## Proposed amendments to the UNECE Regulation No. 29 on truck cab safety

### OICA comments to Informal Document GRSP-44-01 (Russian Federation)

GRSP-44  
December 2008

## Frontal impact N vehicles above 7.5t GVM (N2 > 7.5t GVM; all N3) OICA POSITION

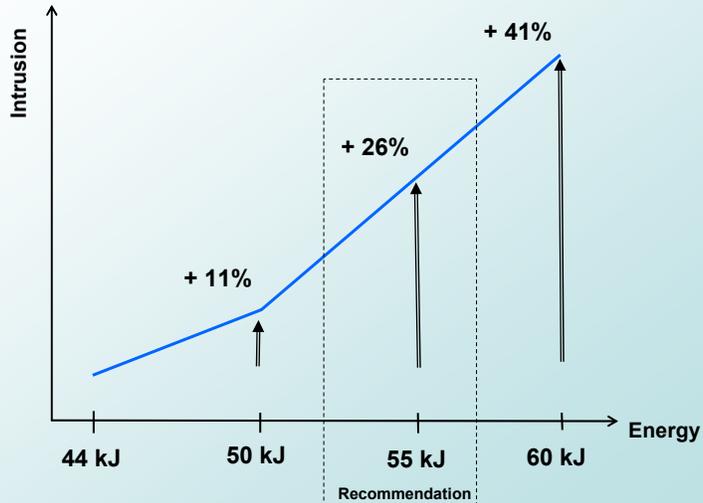
1. Energy level: the proposed energy level of almost 60 kJ seems excessive for several cab designs (see following slide) and OICA proposes a maximum energy level of 55 kJ (compromise between the original proposals from Russia (60kJ) and from OICA (50 kJ))
2. OICA fully supports the proposal that "conventional" trucks would be exempted from the impactor test (the same exemption should apply to vehicles  $\leq 7.5t$ ), but suggests the following wording:

The impactor test only applies to Cab Over Engine (COE) vehicles (*also called Forward Control Vehicles in European texts*)

A forward control/COE vehicle is a vehicle where more than half of the engine length is rearward of the foremost point of the windshield base and the steering wheel hub is in the forward quarter of the vehicle length (See European Directive 2007/46, Annex 1, footnote z)

## Front pillar impact

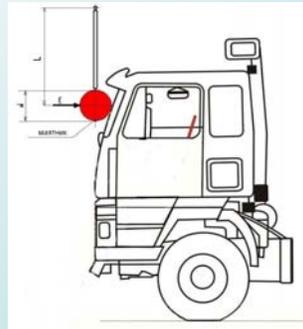
OICA believes that the proposed A-pillar lacks does not fully represent the deformation patterns observed in available real world data

OICA however can accept the Russian proposal as a compromise, with the following comments:

- **Impactor diameter: 600 mm seems the most suitable**
- **Impactor mass: the upper limit should be deleted, i.e. "mass  $m \geq 1000$  kg"**

## Roof Strength

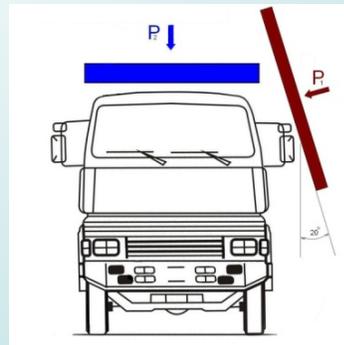
OICA fully supports this proposal with following suggestions:

- **Dimension of plate:** delete all dimensions and replace with the requirement that "The platen shall be sufficiently large and positioned such that the cab will contact only the interior of the platen, not the edges."
- **Pendulum impactor:** in addition to a pendulum impactor, alternative procedures at choice of manufacturer should be allowed
- **Impactor mass:** the mass should be minimum 1500 kg, without maximum

## Back Wall Strength N vehicles

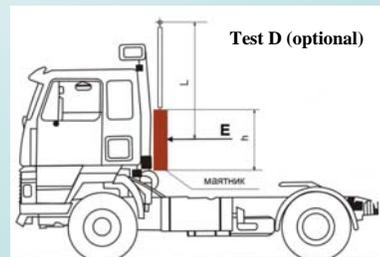
- OICA recognises that the back wall test is already part on UNECE R29 as an option to the manufacturer
- However, no data exist to justify maintaining this test
- The back wall test should therefore be deleted altogether for all N vehicles
- If the back wall test is retained:
  - ✓ It must remain optional at the choice of manufacturer
  - ✓ It can only apply to vehicles with a separate cab.
